**PRELIMINARY SITE PLAN**  
**FOR**  
**MULLAN SHORT PLAT**  
**A PORTION OF SECTION 28, TOWNSHIP 20 N., RANGE 04 E., W.M.**  
**CITY OF PUYALLUP, PIERCE COUNTY, WASHINGTON**

**PRELIMINARY SITE PLAN**

**MULLAN SHORT PLAT**

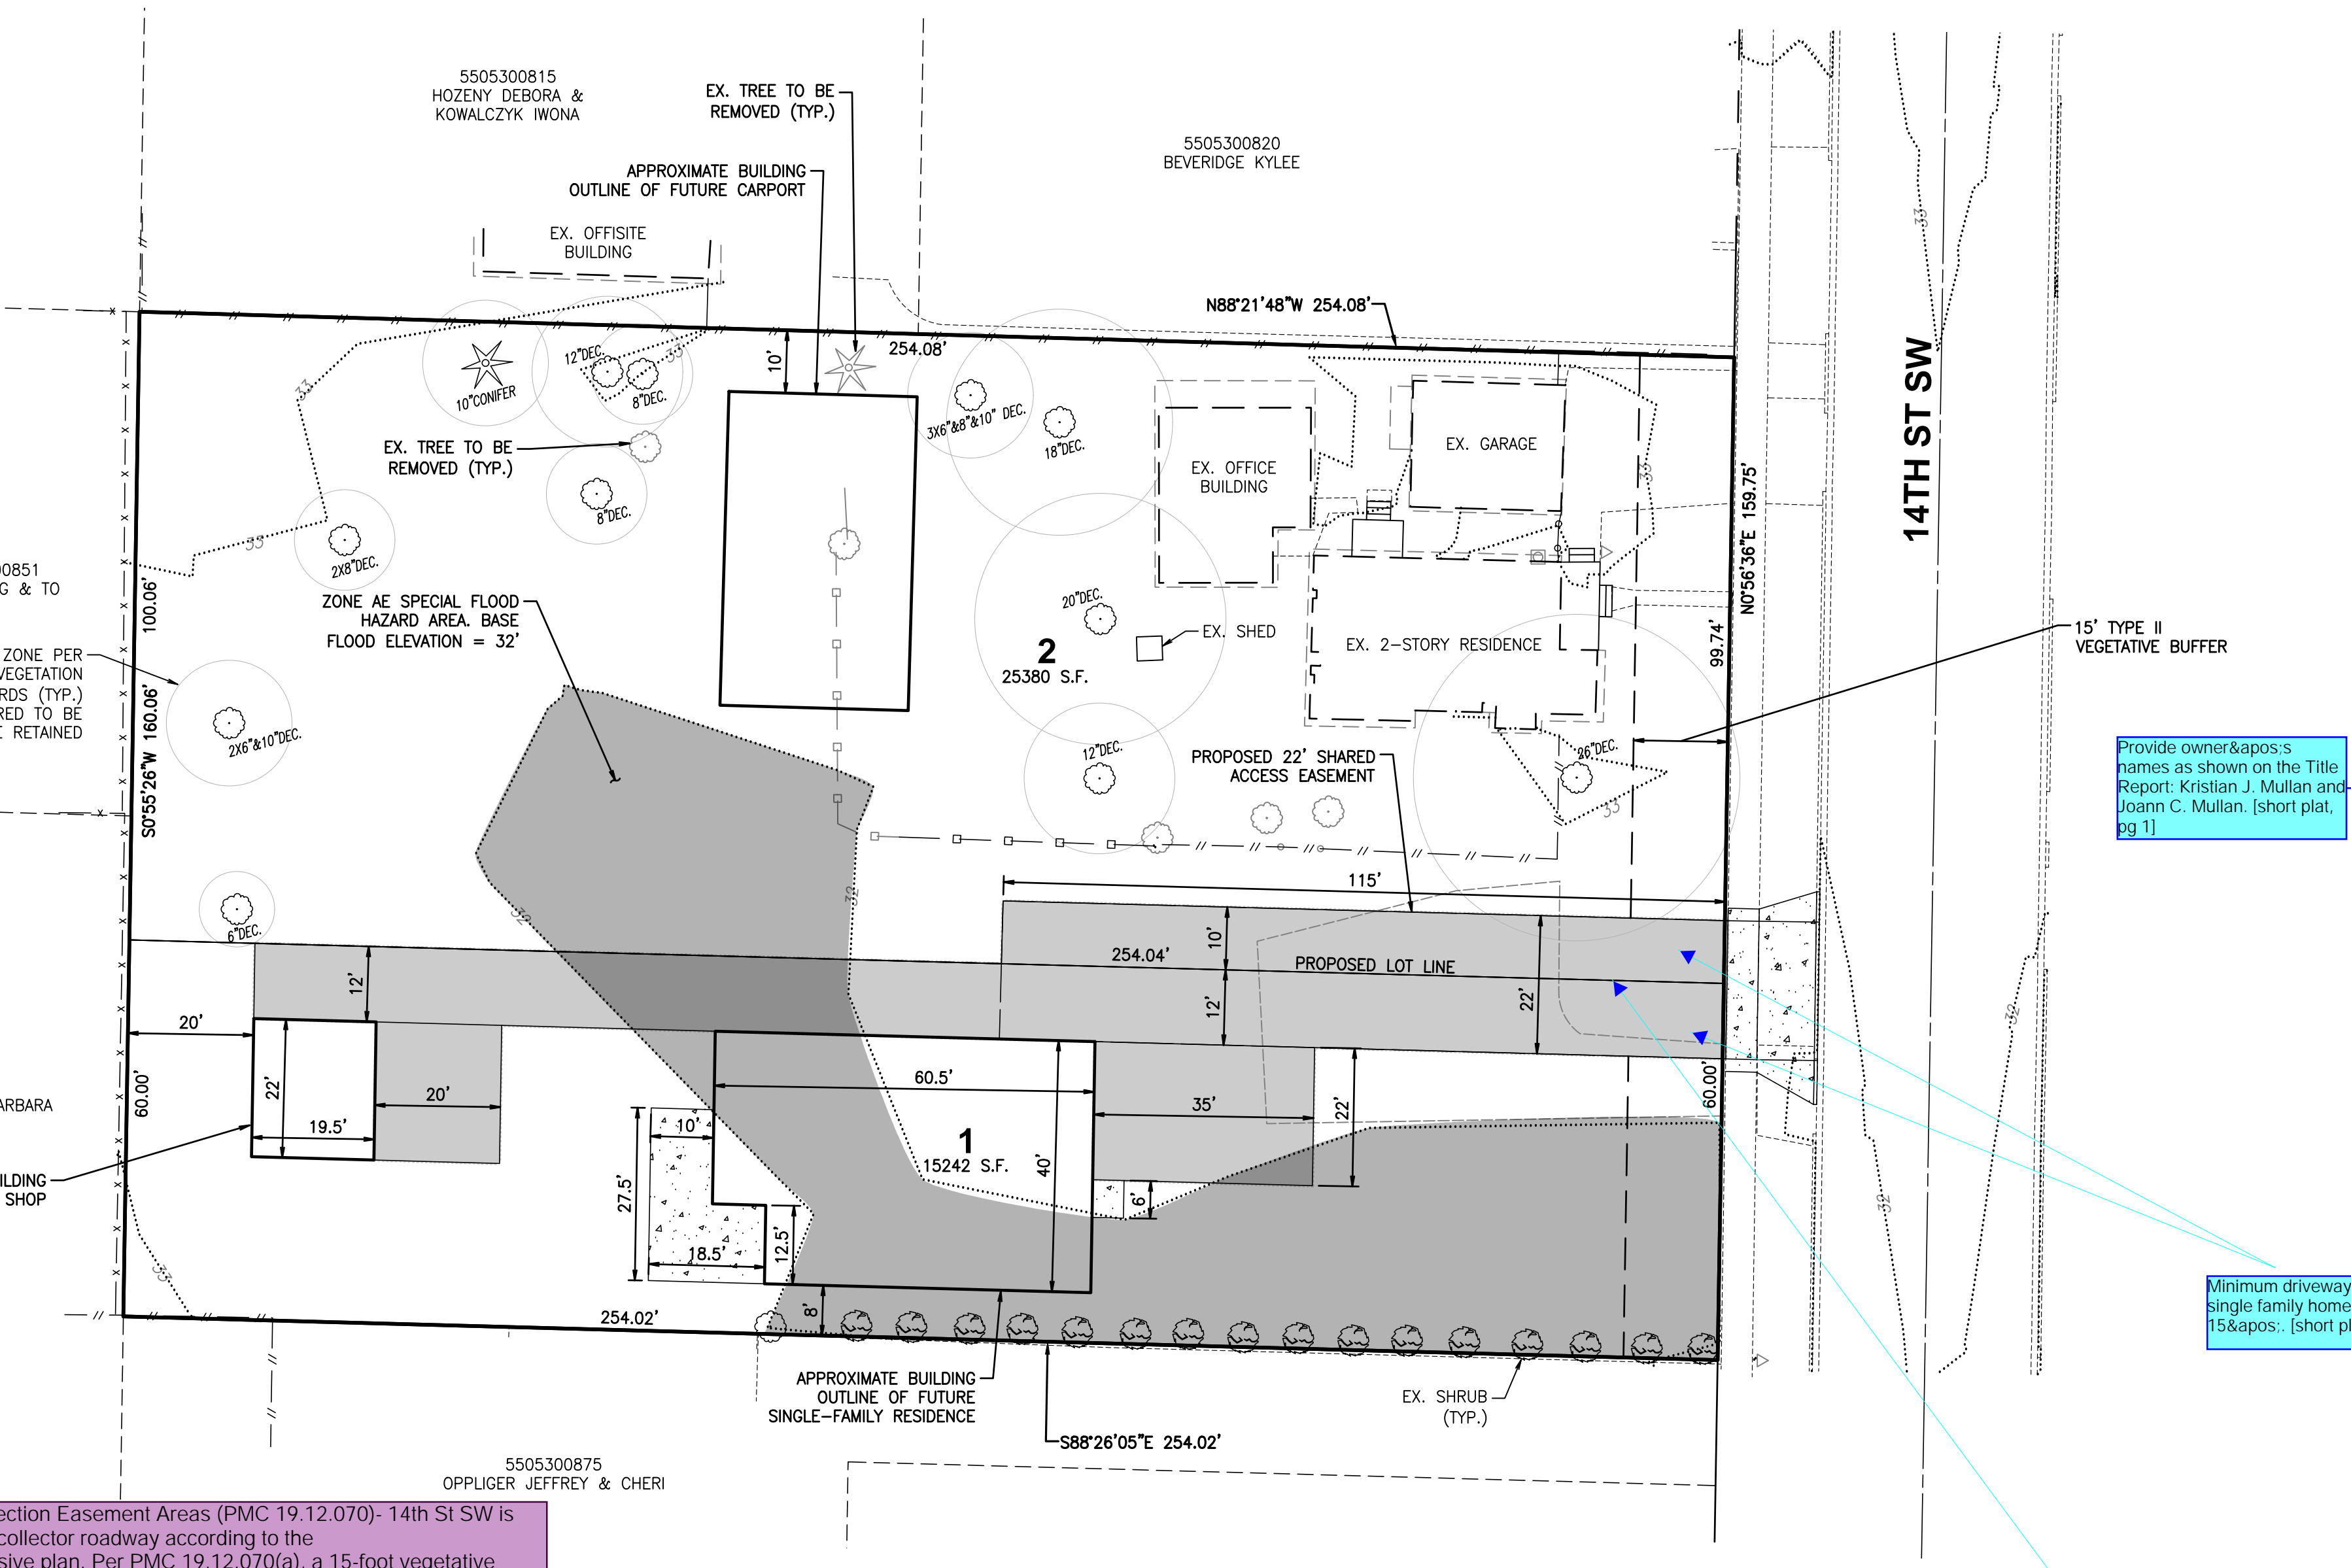
Add this note to the face of the short plat document. A preliminary Storm Drainage Plan is on file for this short plat. No Building Permits will be issued for any lots in this short plat until all necessary drainage improvements are approved and permitted by Development Services Engineering. Compliance may require the property owner/builder to retain a Professional Engineer to design the stormwater controls for the individual lots? [short plat, pg 1]

Add this note to the face of the short plat document. No Building Permits will be issued for Lot 1 through Lot 2 until City approved utility and road improvements are reviewed and approved to include curb, gutter, sidewalk, roadway base, pavement, water, sanitary sewer, storm infrastructure and street lighting.? [short plat, pg 1]

Add this note to the face of the short plat document. NOTICE: This short plat contains a private storm drainage system. Private storm drainage systems are the sole responsibility of the owners, successors, and assignees for all lots being served by the private storm drainage system. Responsibility includes, but is not limited to, constructing, maintaining, and allowing City inspection of the private storm system in accordance with a separately recorded stormwater management facilities agreement recorded with Pierce County. Ref. AFN \_\_\_\_\_? [short plat, pg 1]

Add this note to the face of the short plat document. Erosion and stormwater control plans shall be required for any new residential development prior to building permit issuance on Lot 1 through Lot 2? -No permanent structures shall be erected within the easement area(s). Permanent structure(s) shall mean any concrete foundation, concrete slab, wall, rocky, pond stream, building, deck, overhanging structure, fill material, tree, recreational sport court, carport, shed, private utility fence, or other site improvement that restricts or unreasonably interferes with the need to access or construct utilities in said easement(s). Permanent structure(s) shall not mean improvements such as flowers, ground cover and shrubs less than 3-feet in height, lawn grass, asphalt paving, gravel, or other similar site improvements that do not prevent the access of men, material, and machinery across, along, and within the said easement area. Land restoration by the City within the said easement area due to construction, shall mean planting grass seed or grass sod, asphalt paving, or gravel unless otherwise determined by the City of Puyallup.? [short plat, pg 1]

Add this note to the face of the short plat document. Prior to building permit issuance for each lot within this Short plat, individual lot Stormwater reports will need to be submitted to verify the calculations in the stormwater report submitted during Short Plat review. The stormwater reports submitted during building permit review are required to contain saturated hydraulic conductivity testing and ground water monitoring during the wet season in accordance with the currently adopted stormwater manual and City Standards.? [short plat, pg 1]

Add this note to the face of the short plat document. The project site is designated a special flood hazard zone and was determined by examination of the Flood Insurance Rate Map(FIRM) Community Panel Number 53053C0341E, dated March 7, 2017. Prior to final building inspection and approval, a FEMA Elevation Certificate must be submitted and approved by the City of Puyallup Engineering Services Department verifying that the structure has been constructed and elevated in accordance with the City's Floodplain Management Regulations. The project site is located in the regulated AE floodplain. Any new construction and substantial improvements in this zone must construct the lowest floor, including basement, a minimum one foot or more above the established base flood elevation. [short plat, pg 1]

Include the updated geotech report with groundwater monitoring information so the preliminary stormwater design can be determined. At this time, I can determine if the flow control requirement is met or not. Provide an in depth breakdown of surfaces that can be modeled as pervious if infiltrated or dispersed per the Ecology manual. [short plat, pg 1]

Provide a legend showing existing/proposed lot lines. The existing lot lines shall be shown using a heavy dashed line, whereas the proposed lines shall be a heavy solid line. [short plat, pg 1]

Include the boundary and topographic survey as part of the short plat document. [short plat, pg 1]

The proposed short plat must be a surveyed plan on City of Puyallup Short plat template found here: <https://www.cityofpuyallup.org/DocumentCenter/View/13810/Short-Plat-Cover-Page-Template-2021-?bidId=1> Note that the survey map submitted has provided a good chunk of the required information outline in the short plat application. [short plat, pg 1]

Provide a calculation for the amount of fill proposed for the project and how the project will provide compensatory storage at equivalent elevations to that displaced. [short plat, pg 1]

Prior to submittal to the city for final signatures, please add a Critical Area note to denote the presence of a Critical Area on Site on the face of the short plat (sheet 1). [short plat preliminary site plan, pg. 1]

A critical aquifer recharge area note for each affected lot shall indicate: "The site is within a high susceptibility/critical aquifer recharge area. Uses and activities on this site shall comply with the city's critical area ordinance (Puyallup Municipal Code 21.06, Article XI). Activities that do not cause degradation of ground water quality and will not adversely affect the recharging of the aquifer may be permitted in a critical aquifer recharge area and do not require preparation of a critical area report, provided that they comply with the city storm water management regulations and other applicable local, state and federal regulations." [short plat preliminary site plan, pg. 1]

Volcanic Hazard Area Lots 1 and 2 contain a volcanic hazard area. A volcanic hazard area note for each lot affected shall indicate: "The site is within a volcanic hazard area. In the event of an eruption of Mt. Rainier, the site is expected to be inundated by pyroclastic flows, lava flows, debris avalanche, inundation by debris flows, lahars, mudflows, or related flooding resulting from volcanic activities. Uses and activities on this site shall comply with the city's critical area ordinance (Puyallup Municipal Code 21.06, Article XII, section 21.06.1260, or succeeding section regarding volcanic hazard areas." [short plat preliminary site plan, pg. 1]

Floodplain Lot 1 and 2 contain 100-year floodplain areas. A note shall be included on the face of the plat for each affected lot indicating: "This lot contains a 100-year floodplain areas, containing a 1% chance every year of flooding/inundation that could affect life, property, structures and improvements. All development and land modifications of floodplain areas requires city approval and consistency with the National Flood Insurance Program (NFIP), the Endangered Species Act (ESA), critical areas ordinance (PMC 21.06) and flood protection ordinance (PMC 21.07), as well as any other applicable state, federal and local laws. Modification of land or vegetation, especially land filling that could reduce flood storage capacity, and/or encroachment/conversion of these areas is strictly prohibited without prior government approval." [short plat preliminary site plan, pg. 1]

Wetland Lots 1 and 2 contain wetland areas and protective wetland buffers. A note shall be included on the face of the plat for each affected lot indicating: "This lot contains a wetland and/or wetland buffer that is protected by federal, state and local regulations. A wetland is a permanently, semi-permanently, or seasonally flooded area of land with a distinct ecosystem based on hydrology, hydric soils, and vegetation adapted for life in water saturated soils. Wetlands provide numerous benefits to the natural environment including water quality, flood control, wildlife habitat, shoreline stability, and aesthetic values. Since the 1780s, Washington has lost 31 percent of its wetland areas, from 1.35 million acres to 938,000 acres, contributing to loss of flood storage and habitat areas. Wetlands are critical to the overall health of watersheds and property owners are key for protecting, restoring, and managing our state's remaining wetland resources. Modification of land or

Update the site plan to include additional wetland critical areas and their buffers as appropriate (Confluence Third-Party Review of Critical Areas Assessment, pg. 4) - Update the site plan accordingly to address floodplain storage concerns (Confluence Third-Party Review of Critical Areas Assessment, pg. 6) [short plat preliminary site plan, pg. 1]

Provide existing and proposed areas for new, plus replaced hard surfaces. [short plat, pg 1]

Provide owner's names as shown on the Title Report: Kristian J. Mullan and Joann C. Mullan. [short plat, pg 1]

Provide existing parcel number Address Lot 1: 810 14th St SW Address Lot 2: 808 14th St SW [short plat, pg 1]

Minimum driveway width for a single family home is 15' [short plat, pg 1]

Provide a map legend [short plat, pg 1]

City standard details 01.02.12 requires a 3' paving from the driveway to any adjacent property lines. [short plat, pg 1]

Add the name and address of the owners to the face of the plat (sheet 1) (PMC 19.02.100 (a)). - Provide the legal description of the existing and proposed lots (PMC 19.02.100 (b)). - Provide the parcel number for the existing parcel at 808 14th St SW (PMC 19.02.100 (c)). - Delineate the existing lot lines using a heavy dashed line, and the proposed lot lines shown using a heavy solid line (PMC 19.02.100 (g)). - Move the square footage of proposed Lot 1 to be outside the approximate building outline of the future SFR (PMC 19.02.100 (h)). - Include the accurate location and dimensions/square footage of all existing and proposed structures, septic systems and utility services, and the distance between structures, improvements and utilities to the adjoining proposed lot lines (PMC 19.02.100 (i)). - Include contour lines to address the topography on the lot by showing existing and proposed contours at five-foot contour intervals except for any portion of the site containing slopes of 15 percent or greater which shall be shown at two-foot contour intervals. The contour intervals shall extend at least 100 feet beyond the boundaries of the site (PMC 19.02.100 (m)). - Update the site plan to delineate the boundaries and associated buffers, development envelopes, or other information for any critical areas as defined or required by Chapter 21.06 PMC (PMC 19.02.100 (o)). [short plat preliminary site plan, pg. 1]

Please submit the proposed short plat along with the completed City of Puyallup Short Plat template linked below: <http://www.cityofpuyallup.org/DocumentCenter/View/13810/Short-Plat-Cover-Page-Template-2021-?bidId=> [short plat preliminary site plan, pg. 1]
